April 1, 2024

PROJECT NAME: MAJOR SITE PLAN FOR HWY 200 STORAGE FACILITY

PROJECT NUMBER: 2023110100

APPLICATION: MAJOR SITE PLAN #30898

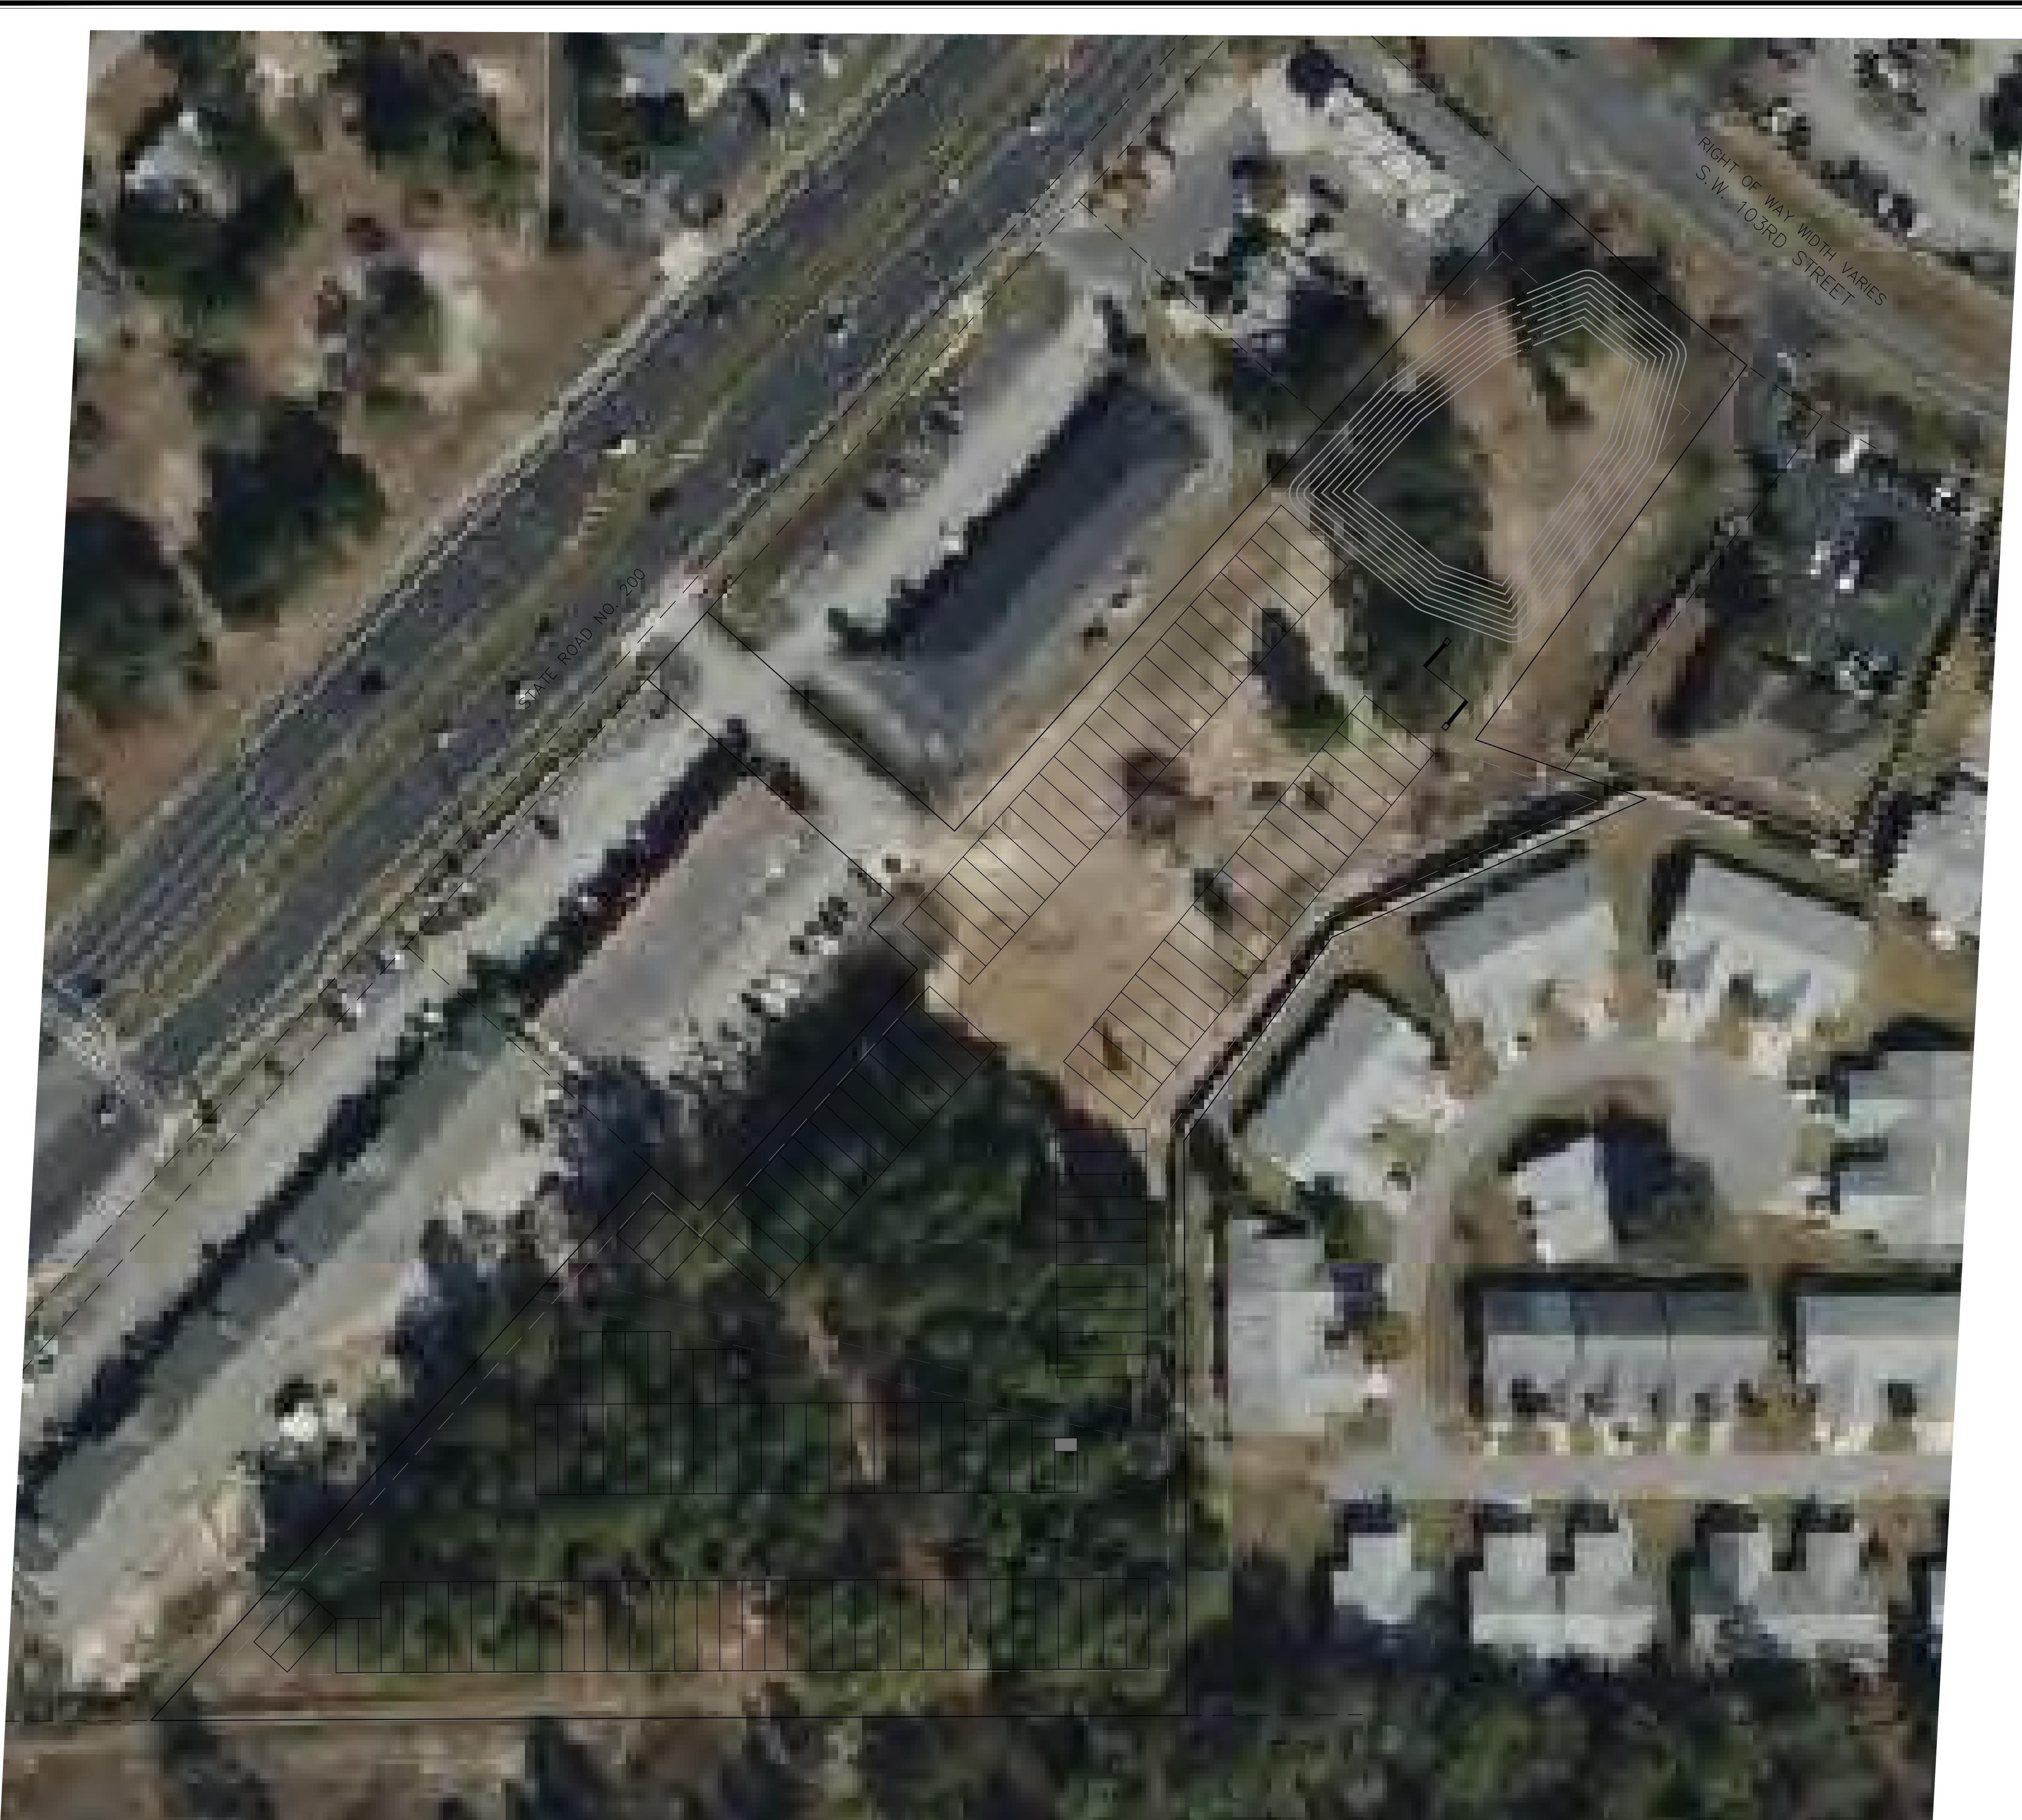
46 DEPARTMENT: 911 - 911 MANAGEMENT
REVIEW ITEM: 2.12.28 - Correct road names supplied
STATUS OF REVIEW: NO
REMARKS: The vicinity map on Sheet 01 has SW 103rd Street Rd incorrectly labeled as SW 103rd Street and SW HWY 200 incorrectly labeled as State Road No 200. Sheets 02, 03, 04, 05, L1, and SW1 have SW 103rd Street Rd incorrectly labeled as SW 103rd Street. Sheets 02, 03, 04, 05, L1, and SW1 have SW HWY 200 incorrectly labeled as State Road No 200.

47 DEPARTMENT: 911 - 911 MANAGEMENT
REVIEW ITEM: 6.2.1.F - North arrow and graphic drawing and written scale
STATUS OF REVIEW: NO
REMARKS: The vicinity map on Sheet 01 has the North Arrow pointing in the wrong direction.

GRADING PLAN
MAJOR SITE PLAN
HWY 200 STORAGE FACILITY
MARION COUNTY, FLORIDA

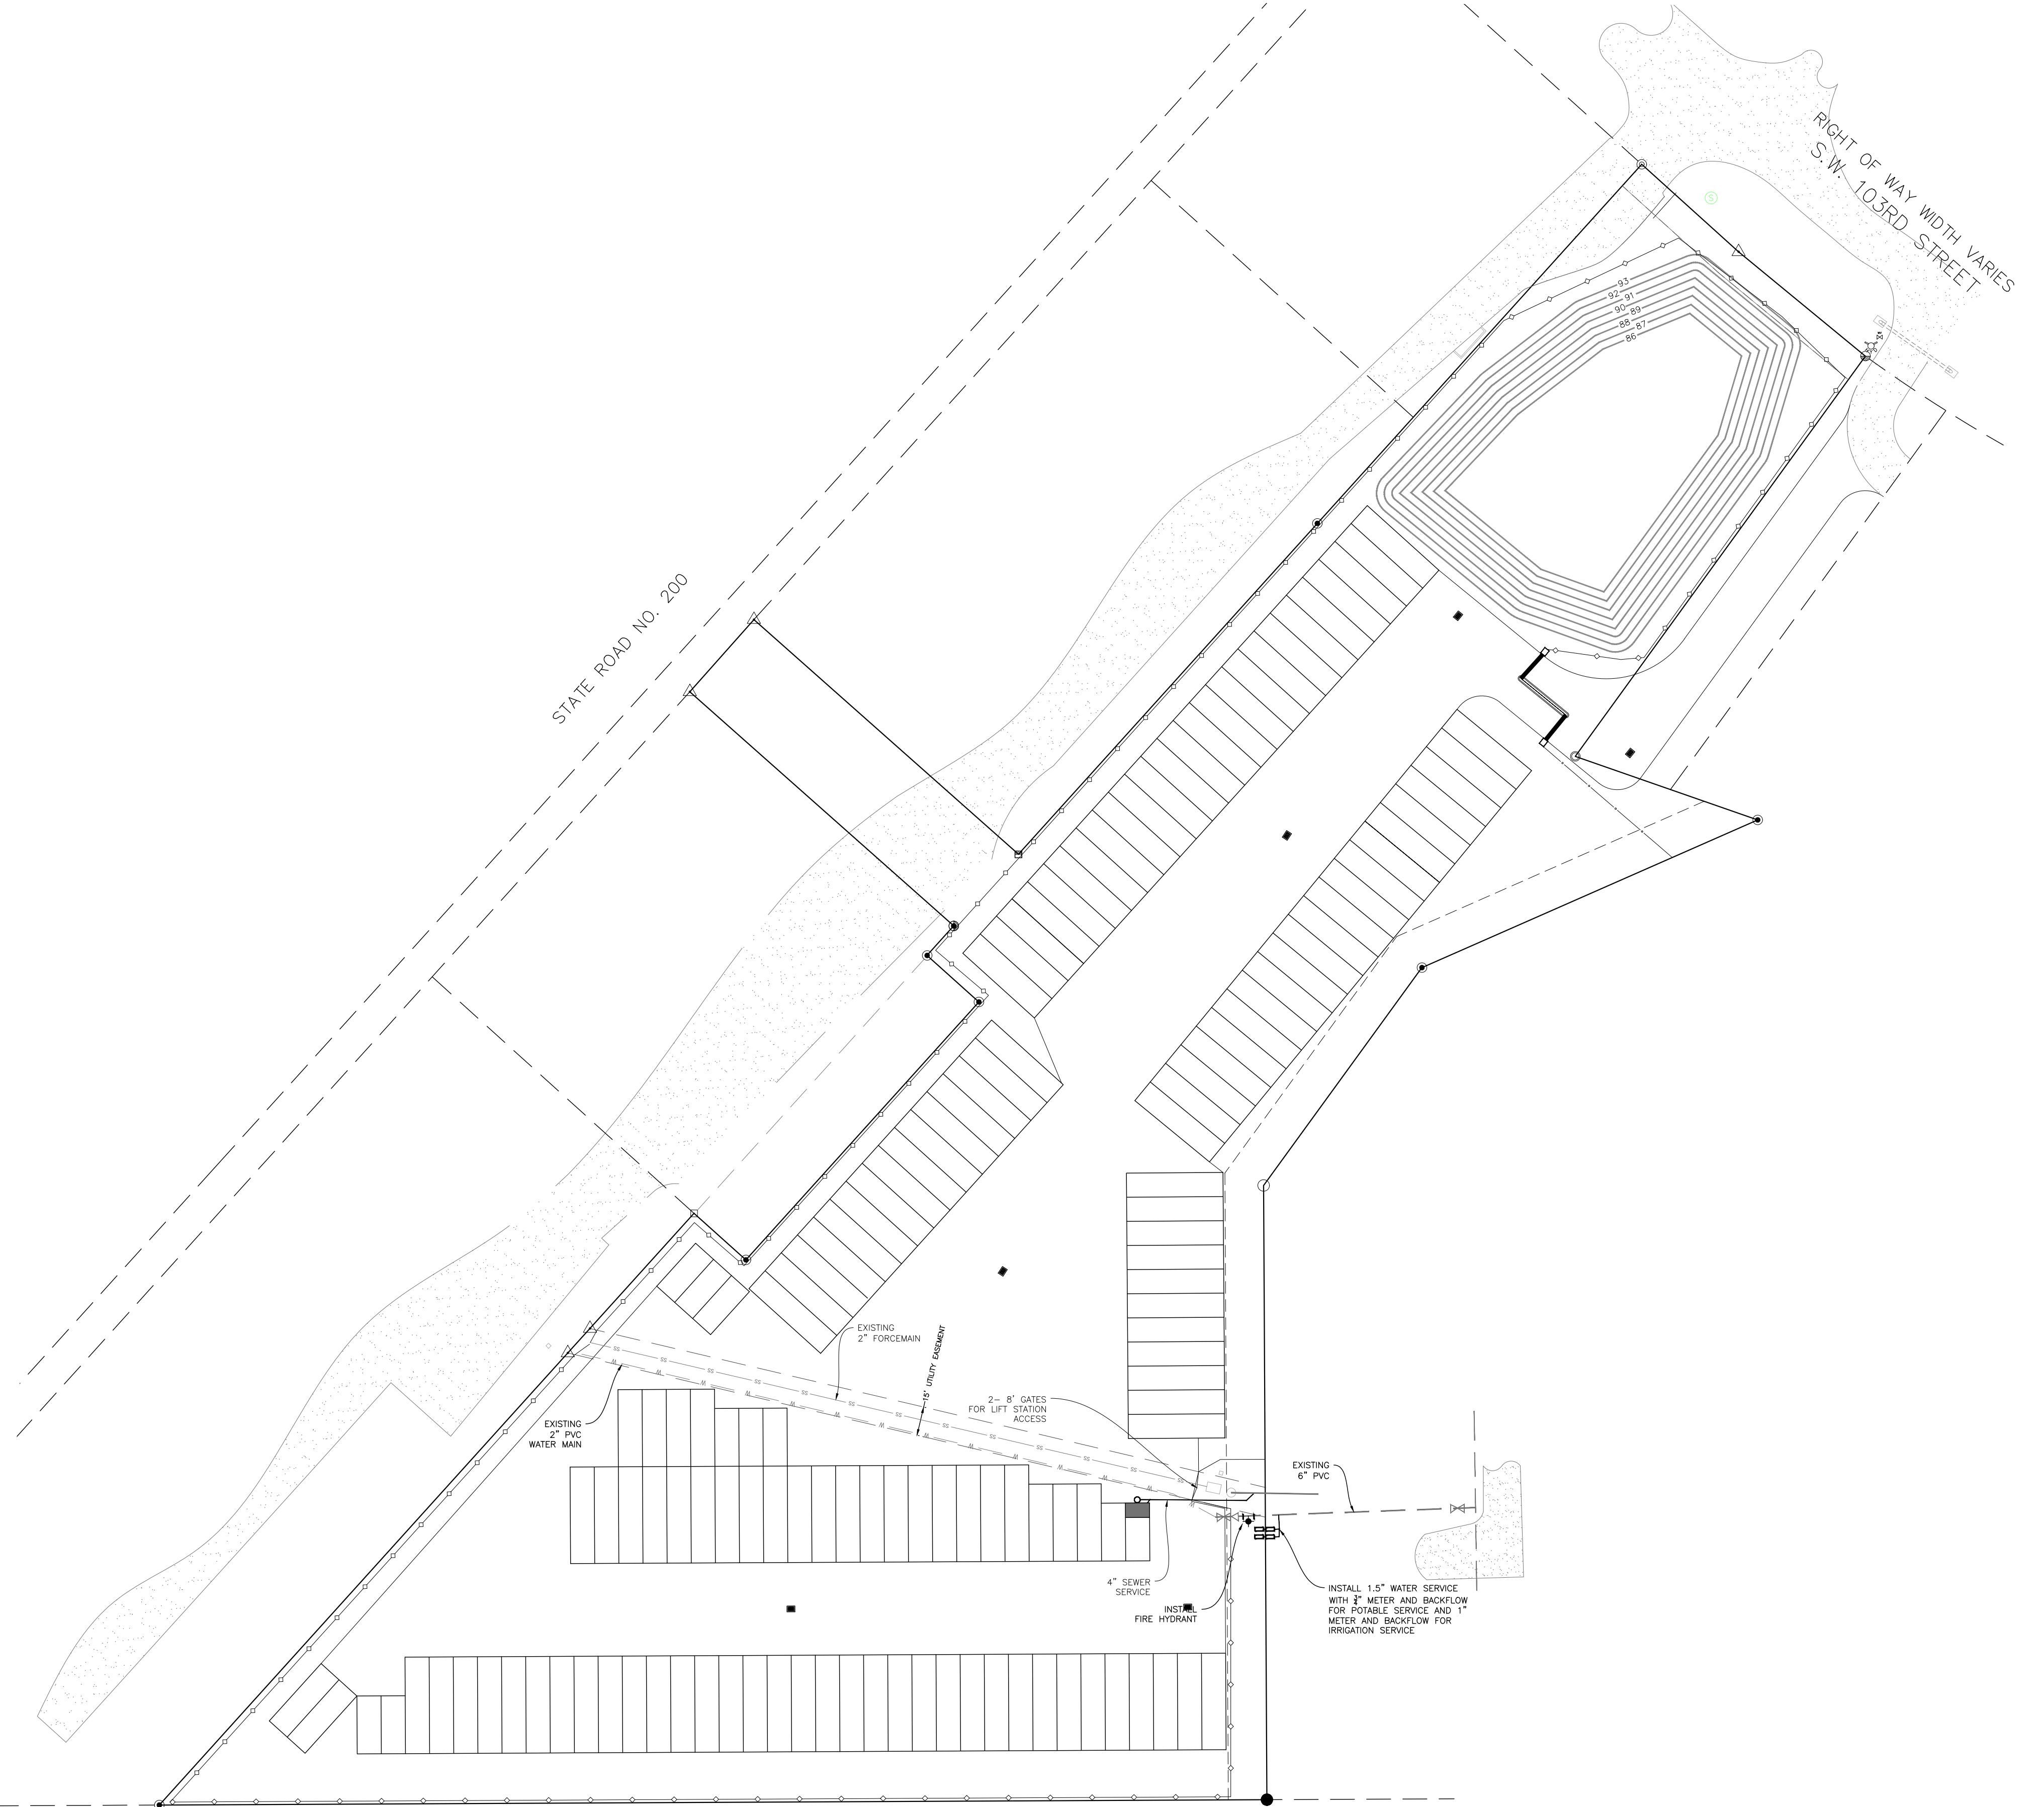
19 DEPARTMENT: ENGDRN - STORMWATER REVIEW
REVIEW ITEM: 6.13.3 - Type of Stormwater Facility Criteria
STATUS OF REVIEW: NO
REMARKS: The maximum pond depth allowed per the LDC is 6ft. The proposed pond is 7 ft deep.

Reason/Justification for Waiver Request: The pond is shown to be 7' deep. It is only holding 5.67' of stormwater. The extra freeboard was used because the DRA has no discharge. Also, bottom of the dra is only 1' below the existing low point in the area of the pond.
